SUBJECT: Forwards Burns & Roe review of BNL comments re effects of
 desynchronization methodology used in generic & plant-unique
 chugging load specs, per Mark II owners group 820209 meeting.
 Structural responses not significant.

Subject: NUCLEAR PROJECT NO. 2
DESYNCHRONIZATION METHODOLOGY
IN CHUGGING LOAD SPECIFICATION

REVIEW OF PROF. BIENKOWSKI'S CONCERN REGARDING
EFFECTS OF DESYNCHRONIZATION ON
THE CHUGGING LOAD SPECIFICATION USED
FOR WPPSS - NUCLEAR PROJECT NO. 2

Fig. 3b-2: WFO 42

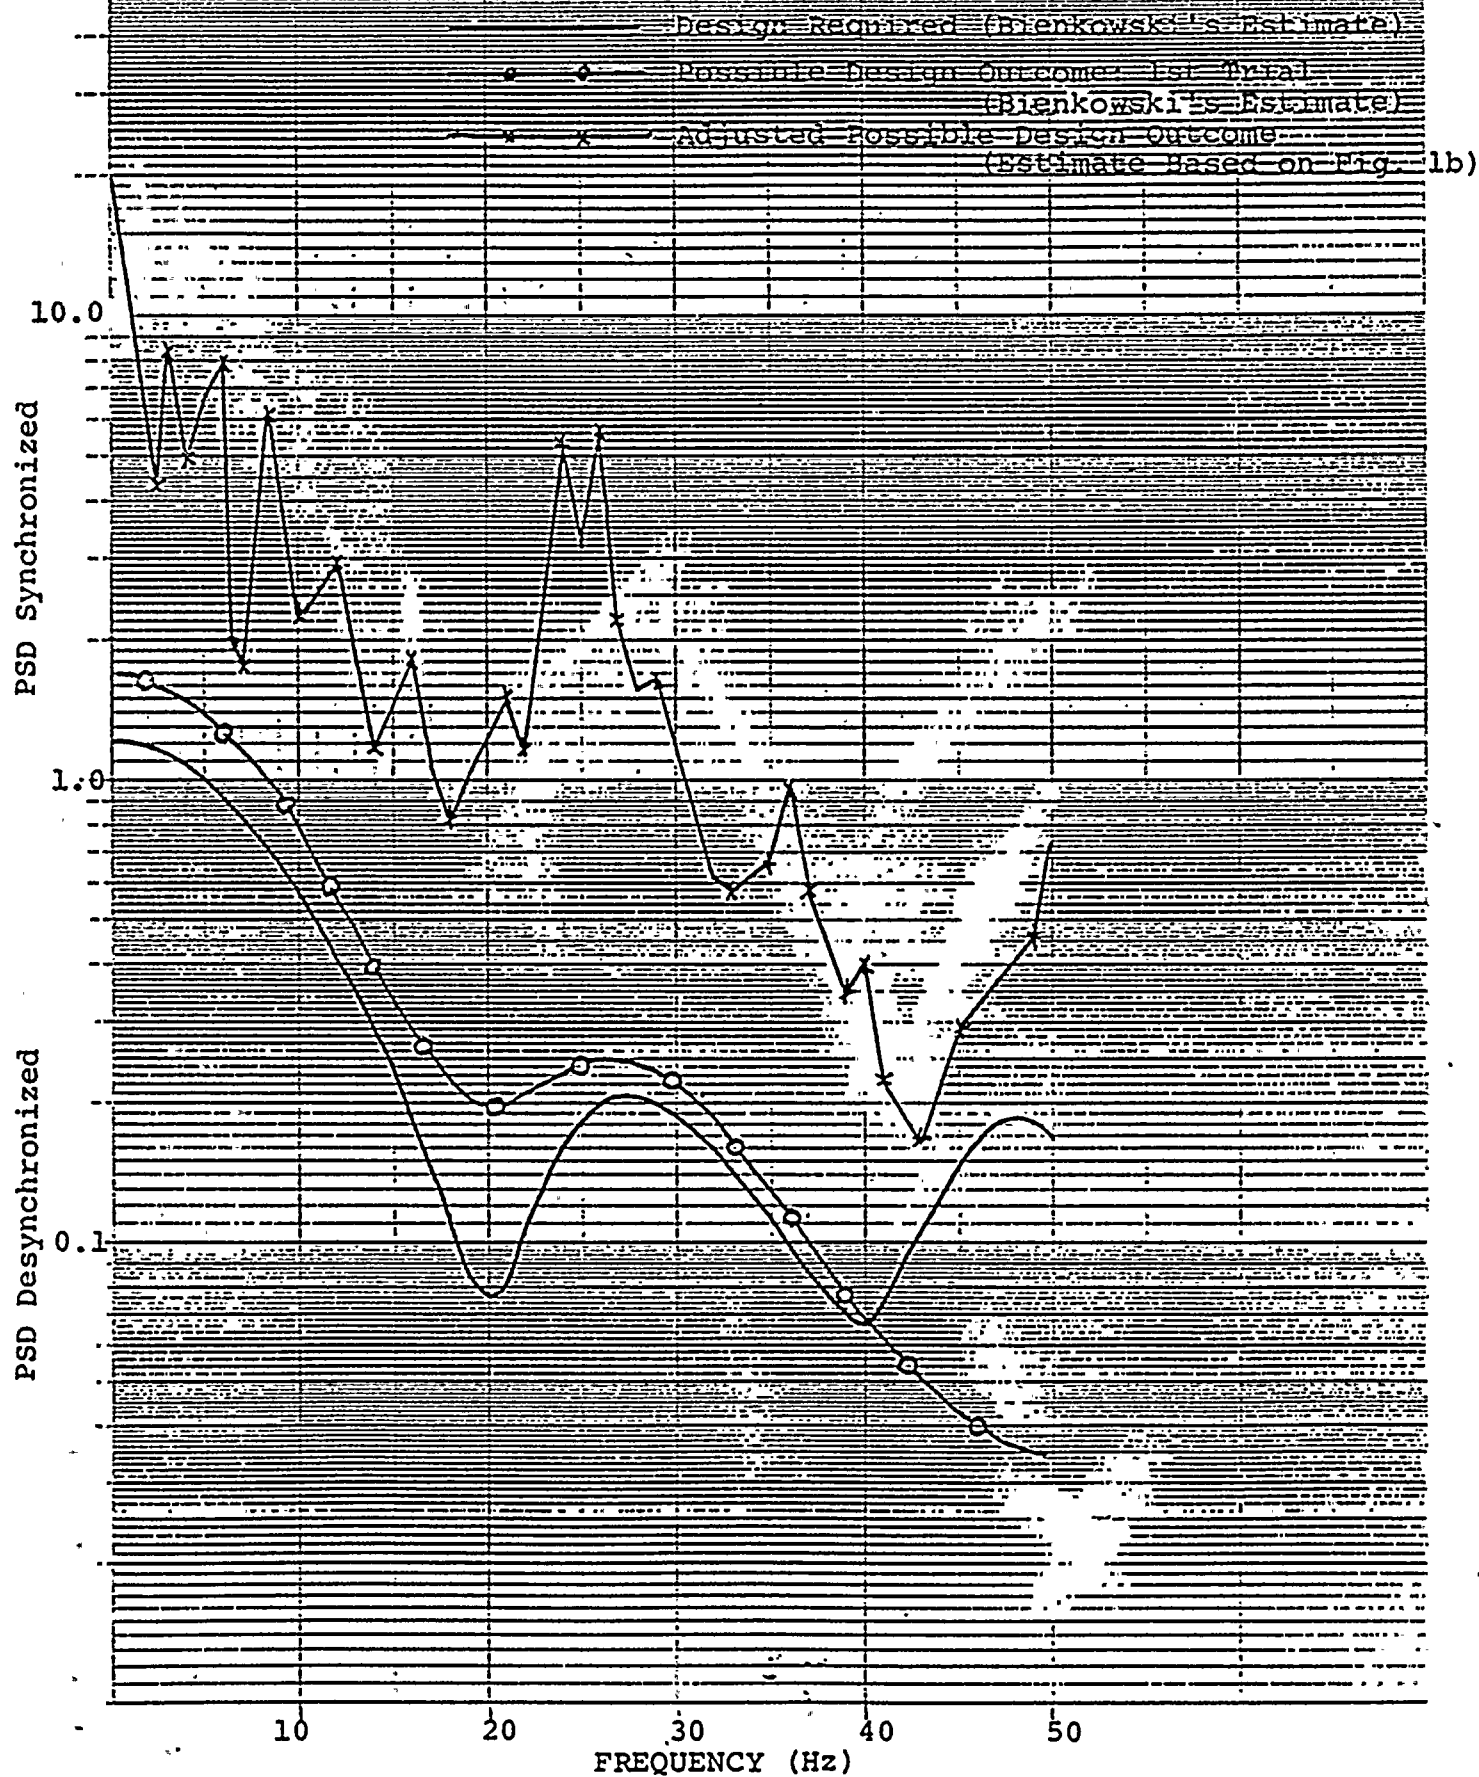
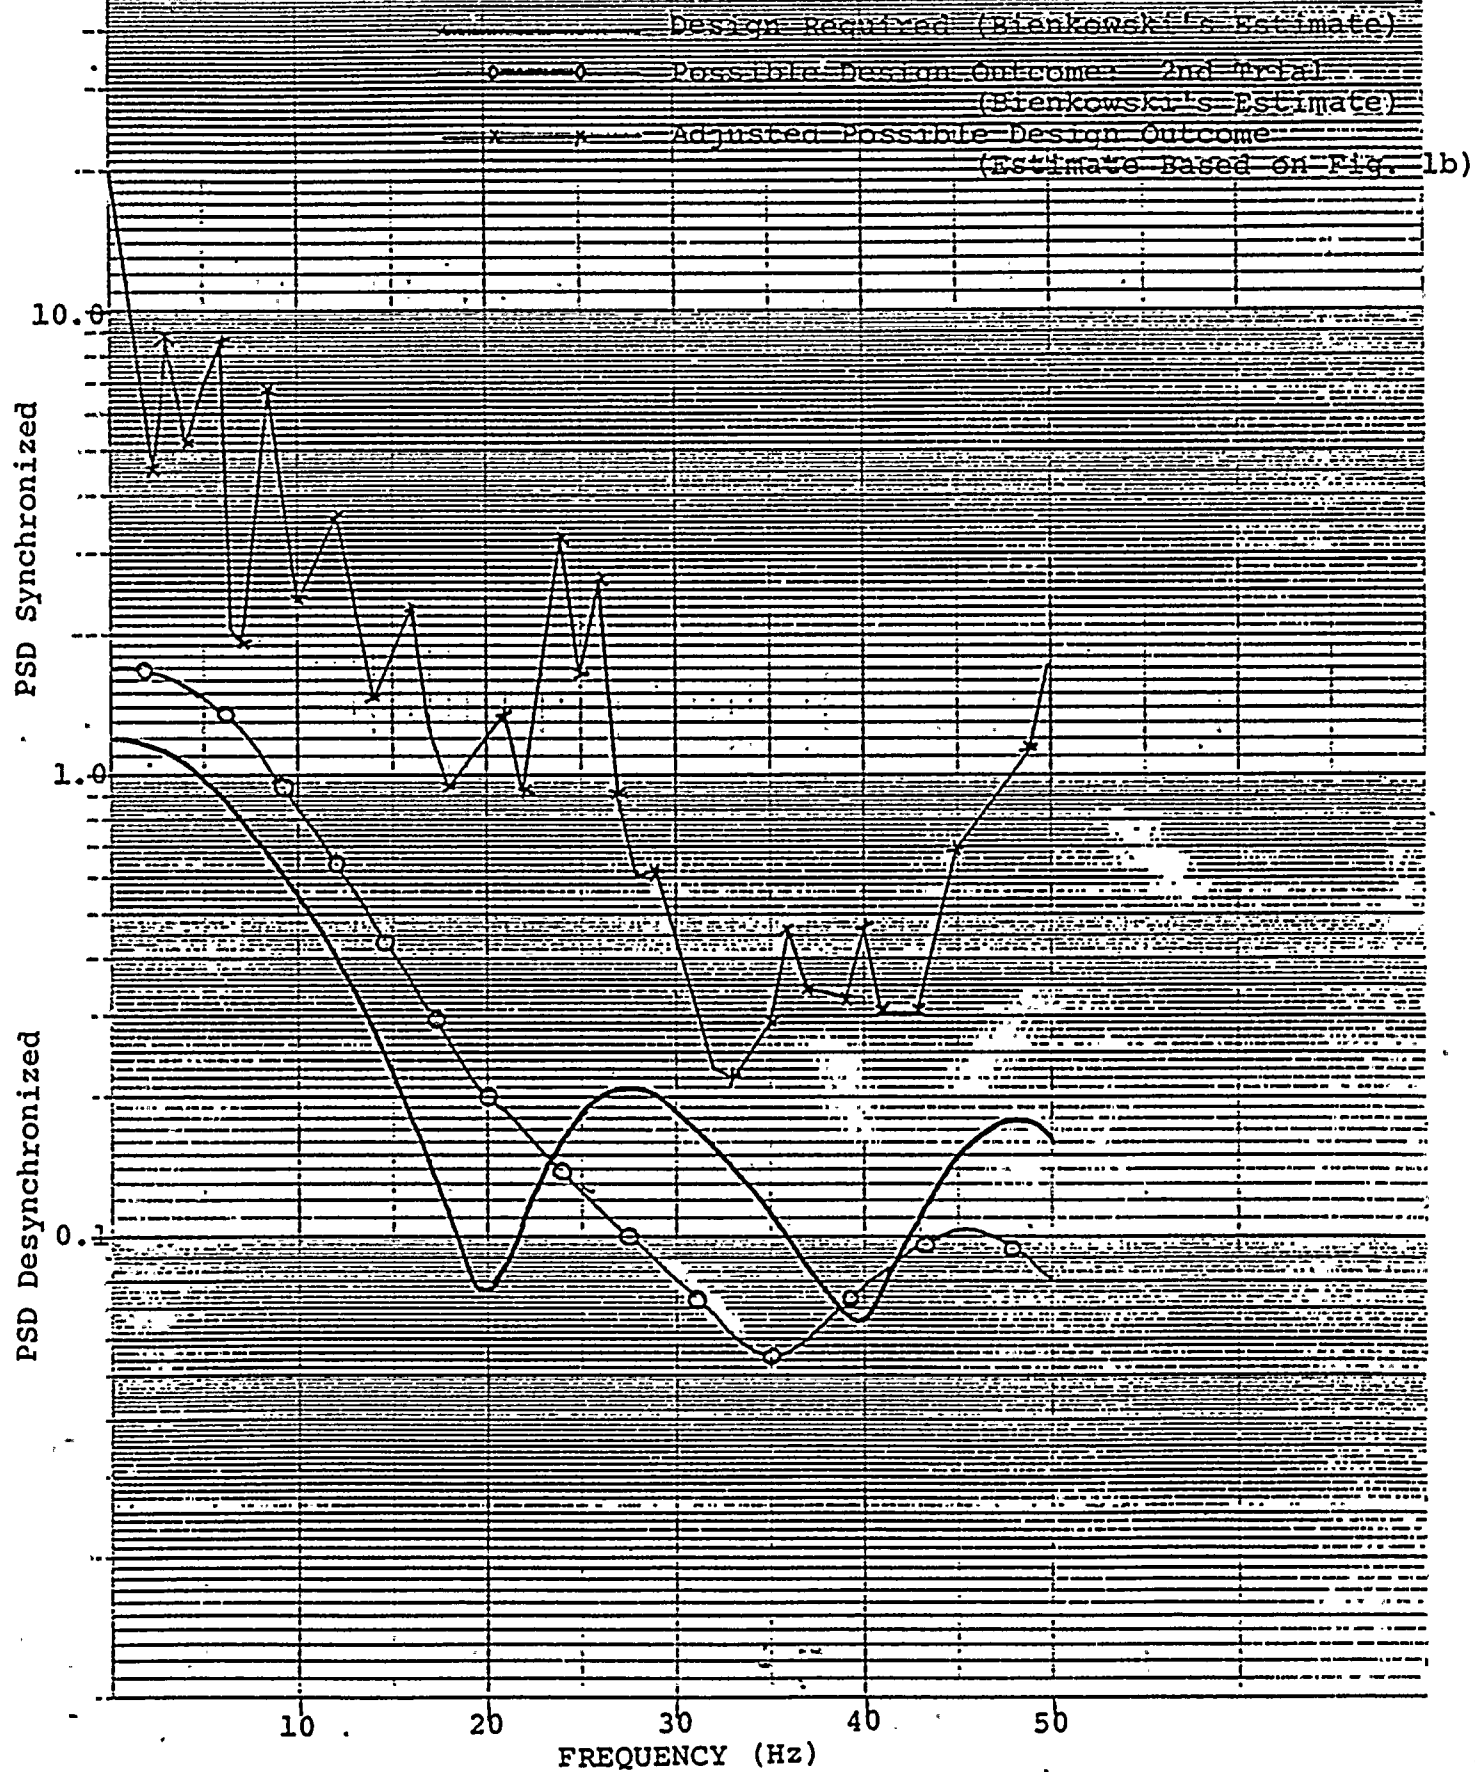
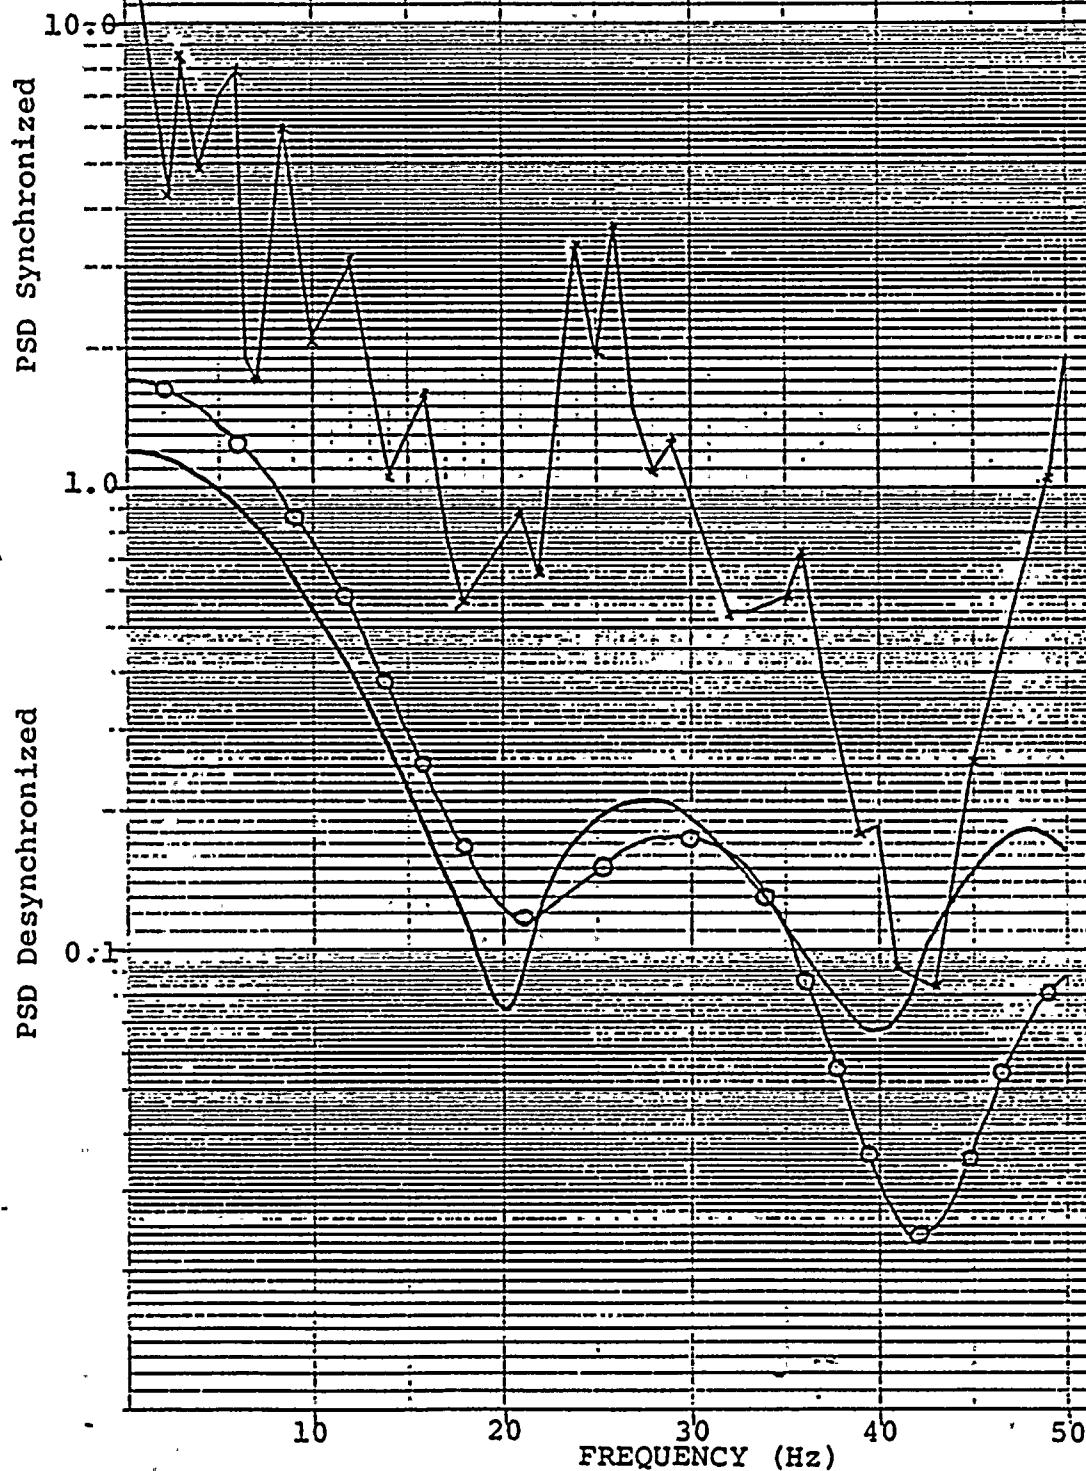
Prof. Bienkowski, as consultant to the NRC, has reviewed the effects of desynchronization on the chugging load; specifically he evaluated the sensitivity of the frequency content of the load to the selection of a single set of start times recommended by the load specification.

Starting, on the basis of "physical" intuition (actually rather historical precedence and practical considerations), with the vertical force and overturning moment acting on the suppression pool bottom as parameters that adequately describe the "major" structural excitations and using the results of calculations based, by necessity, on simplifying assumptions, Prof. Bienkowski reached the tentative conclusion that the desynchronization specification may result in frequency "holes" at some frequencies, mainly in the 20 Hz to 50 Hz range. It thus appears that the present chugging load specification may be deficient in this frequency range.

B. As discussed earlier in this letter-report the single-vent design "source" loads derived for application to WNP-#2 enveloped the 4TCO test data base by a good margin (see Figure 1). When this conservatism in design loads is duly accounted for, the desynchronization methodology used with the chugging load definition is shown to be adequate. Indeed, Figure 3 shows a comparison, frequency by frequency, for WNP-#2 vertical force in terms of the ratio = (PSD for-desynchronized application/PSD for synchronized application) between:

- a) required design values (or "true" bound of 1000 Monte Carlo trials) estimated by Prof. Bienkowski,
- b) (three) possible design outcome values (Prof. Bienkowski's estimates), and
- c) the same (three) possible design outcome values adjusted to account for conservatism in single-vent design "source" load definition.

As seen from Figure 3, when adjusted for conservatism in the design load definition, the possible design outcome values envelope by a good margin the required design values.

It should be noted here that the comparisons of Figure 3 are only estimates since the analytical procedures implemented on WNP-#2 (including software package) were not available to Prof. Bienkowski for use. It is believed that if these analytical procedures were to be used the comparison will be even more favorable.

It is therefore concluded that the present chugging load specification (including desynchronization) is adequate.

Fig. 4: COMPARISON OF PREDICTED/CALCULATED (USING WNP-#2 CHUGGING LOAD SPECIFICATION) AND MEASURED PRESSURES IN JAERI - VENT EXIT ELEVATION -

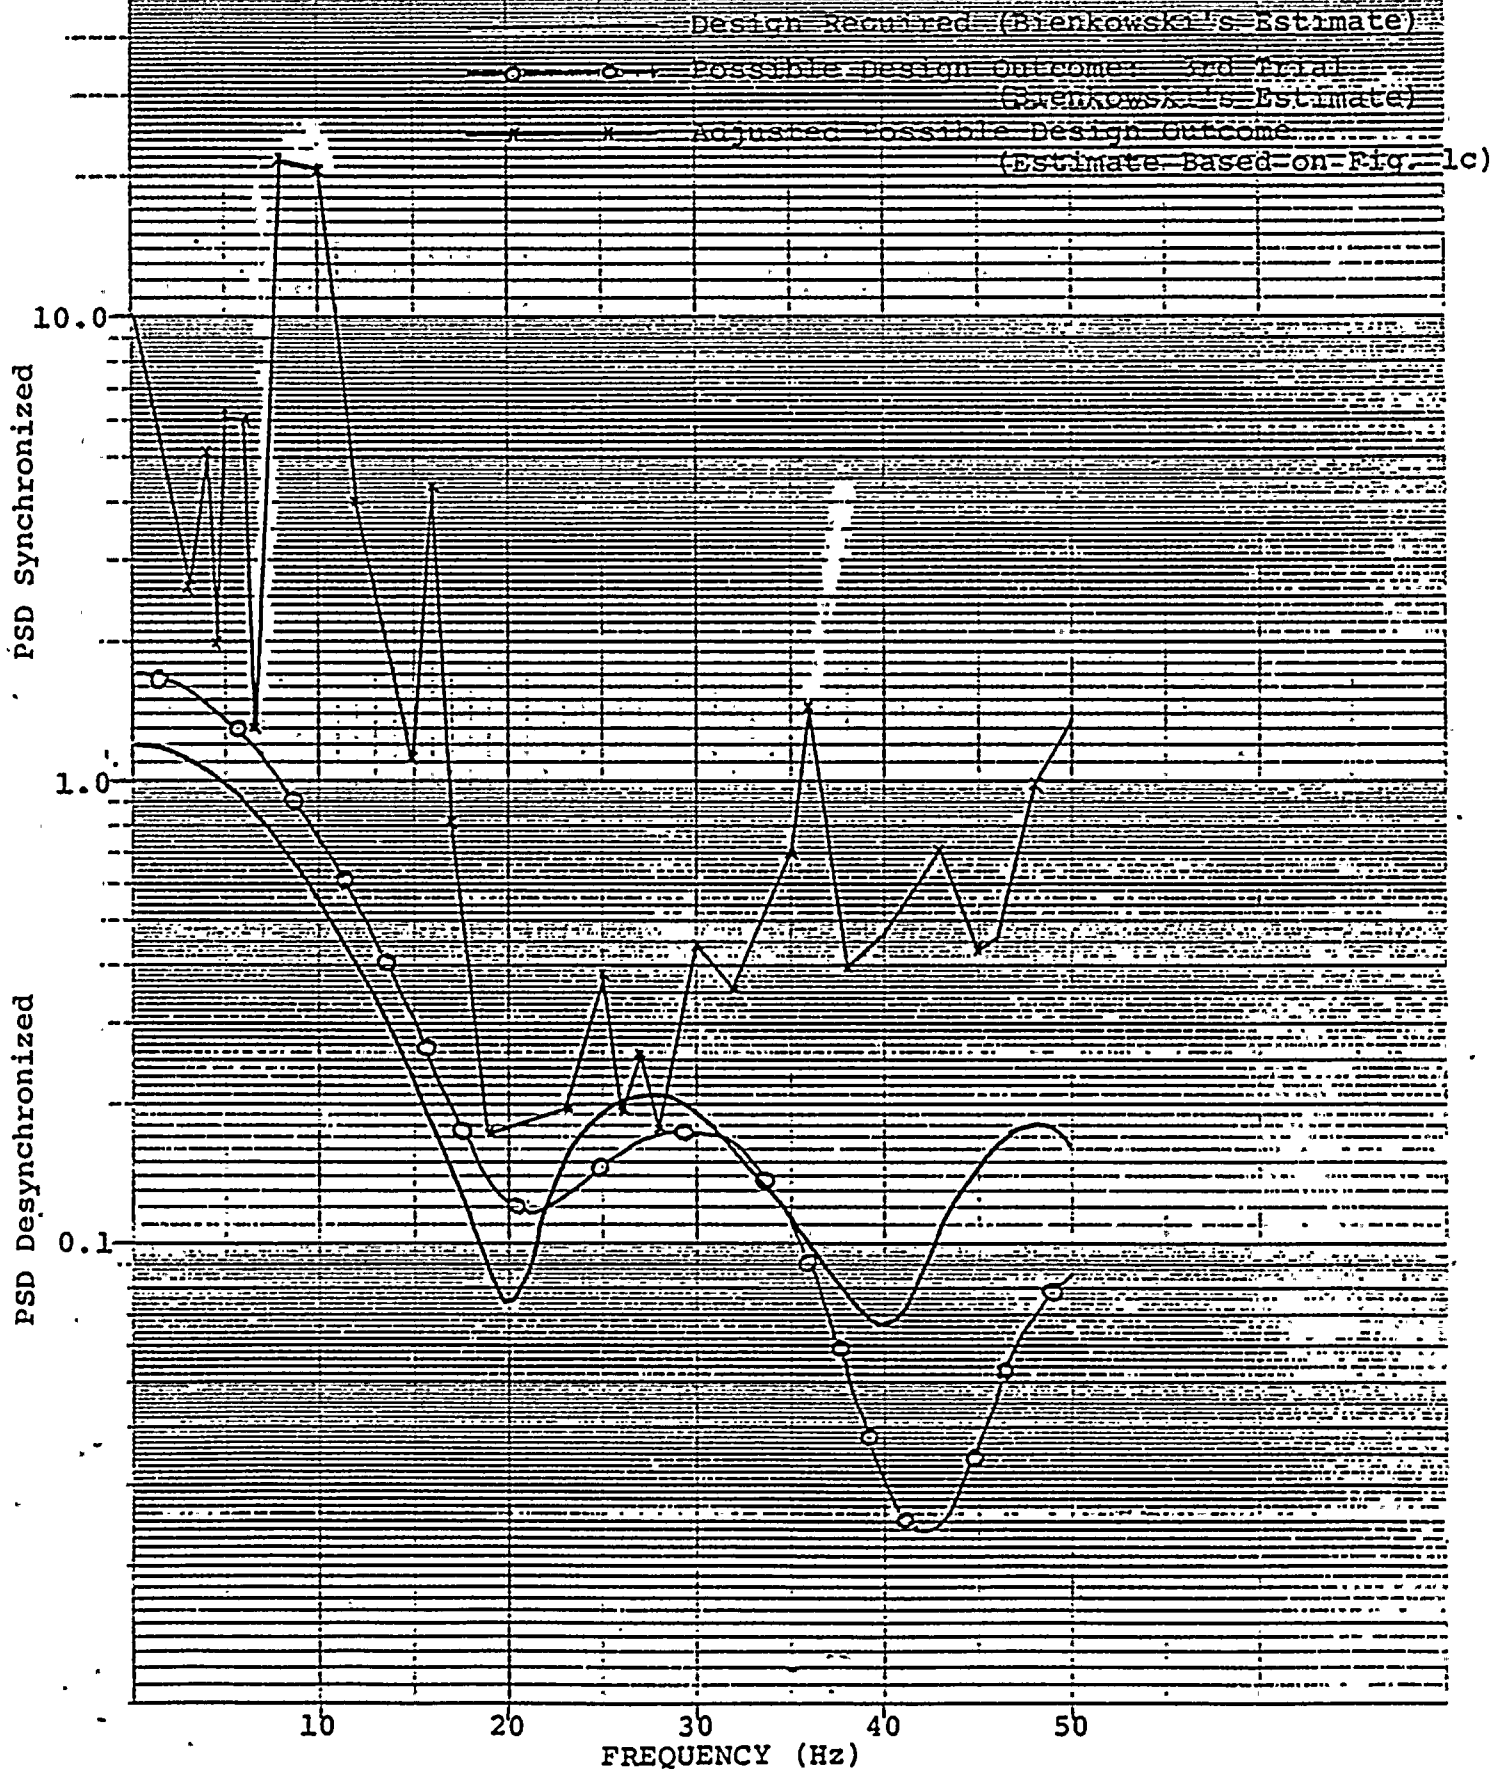
C. The multi-vent full scale test facility most representative of the Mark II suppression pool geometry is JAERI's seven vent tank. The NRC staff has previously requested to apply the WNP-#2 chugging load specification to the JAERI test facility and to compare the pressures calculated on its boundary with those recorded during the JAERI chugging tests. A number of chugging tests were already completed in this facility and some of the recorded data already processed, including data from Test 0002 during which some of the largest chugs were recorded³.

If the chugging load specification derived for WNP-#2 (including desynchronization) is applied to the JAERI tank the "rigid wall" pressures calculated on its walls at the vent exits elevation bound, and by a significant margin, the

recorded test data. This is illustrated in Figure 4. The JAERI test data represents the envelope of the eight largest chugs from Test 0002. The envelope is obtained as described in Reference 3, with the exception that the spatially averaged pressure history was computed only from four wall sensors located on the concrete walls of the tank: WWPF-202, 302, 602 and 702 instead of the six wall sensors available (WWPF-202 to 702) used in the Reference 3 comparison. The result thus obtained is more representative of the incident pressure (or "rigid wall" load) and, therefore, comparable with the incident pressure predicted/calculated using the WNP-#2 chugging load specification.

Comparative examination of the results plotted in Figure 4 leads to the conclusion that the present chugging load specification (including desynchronization) of WNP-#2 is adequate.
